UNITED STATES PATENT AND TRADEMARK OFFICE

Office Action Summary

10/553,847

DETAILED ACTION

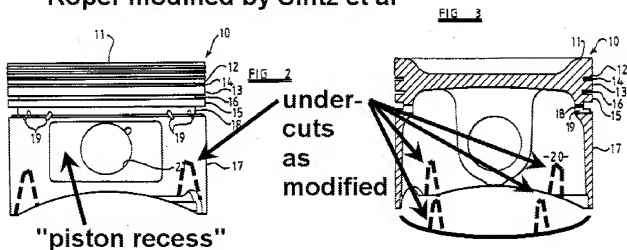
9. Nevertheless, with reference to Figures 2 and 3 depicted above, Roper discloses a piston with the following piston surface details:

- a skirt surface at the connecting portion side of the piston as depicted
- a top surface at the cylinder side of the piston as depicted
- an outer circumferential surface (having the "piston recess") parallel to the cylinder
- a pin hole (21) formed diametrically through the piston as depicted
- a piston pin ("gudgeon pin" as stated in Column 3, Line 28)
- "piston recess" as annotated (one at each end of the piston pin hole as better identified in Figure 4) that opposite ends of the piston pin hole open into, are formed at diametrically opposite locations of said piston

Roper modified by Sintz et al

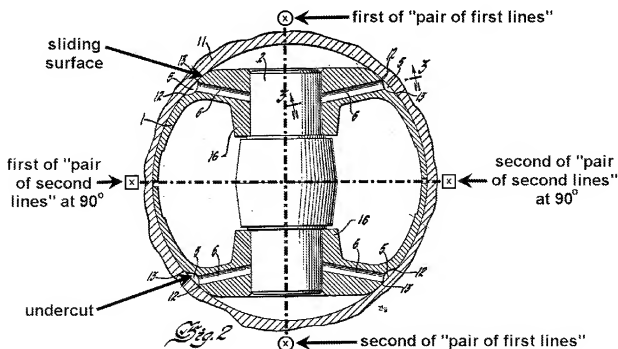
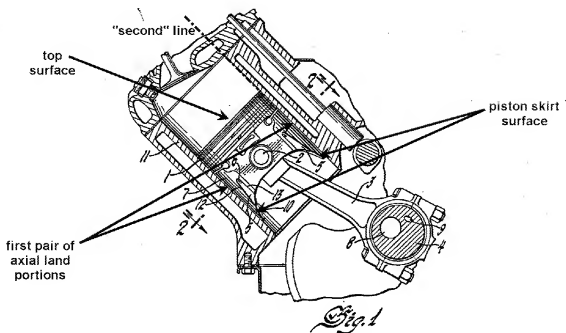
12. Nevertheless, with reference to Figures 1 and 2 depicted above, Sintz et al disclose at least one under cut (5) formed in the outer circumferential surface that is recessed with respect to the outer circumferential surface:

- wherein a pair of first lines (annotated) are defined at the outer circumferential surface of the piston so as to be parallel to the piston axis and so as to intersect the center axis of the piston pin, the first lines being respectively defined at mutually diametrically opposite locations of the outer circumferential surface of the piston pin with respect to the piston axis;
- wherein a pair of second lines (annotated) are defined, at the outer circumferential surface of the piston so as to be parallel to the piston axis and so as to be spaced 90° circumferentially from the first lines with respect to the piston axis, the second lines being respectively defined at mutually diametrically opposite locations of the outer circumferential surface of the piston with respect to the piston axis;

Roper

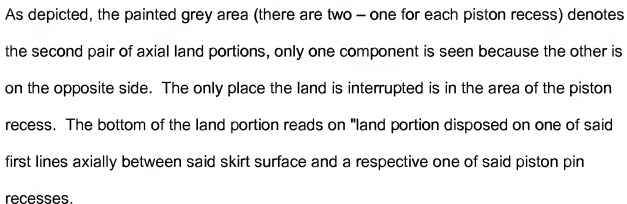
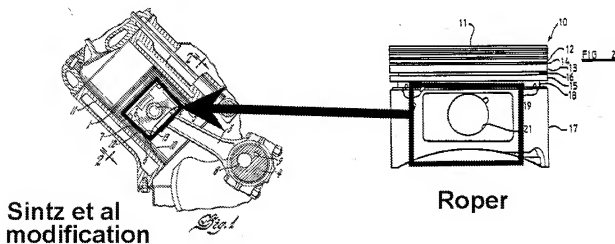
14. ALTERNATIVELY, It would have been obvious to a person having ordinary skill in the art at the time of the invention to modify the portion of the piston of Sintz et al (annotated below enclosed in the rectangle) to resemble the portion (annotated below enclosed in the rectangle) of the piston of Roper thereby having a piston pin recess for the purpose of retaining extra lubricant during the discharge stroke.

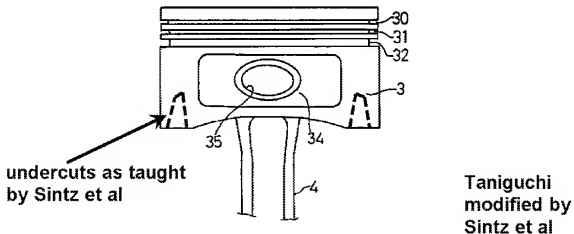
22. In Re claims 16, 18, 20 and 22, Figure 2 of Sintz et al depicts that the four undercuts (5) are equally spaced around the circumference.

23. In Re Claim 23, the two vertical legs of the painted portion in the above figure depicting Sintz et al's undercut modification to Roper read on the portion that extends axially continuously from the circumferential land portion to the skirt surface.

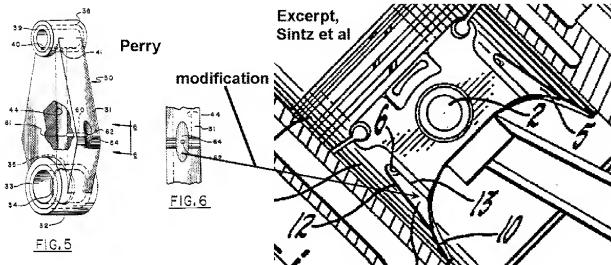
26. Nevertheless Taniguchi as depicted above depicts the piston pin recesses.

27. Taniguchi modified with the undercuts of Sintz et al as annotated in the Figure above in the same way as discussed earlier discloses all the claimed limitations.
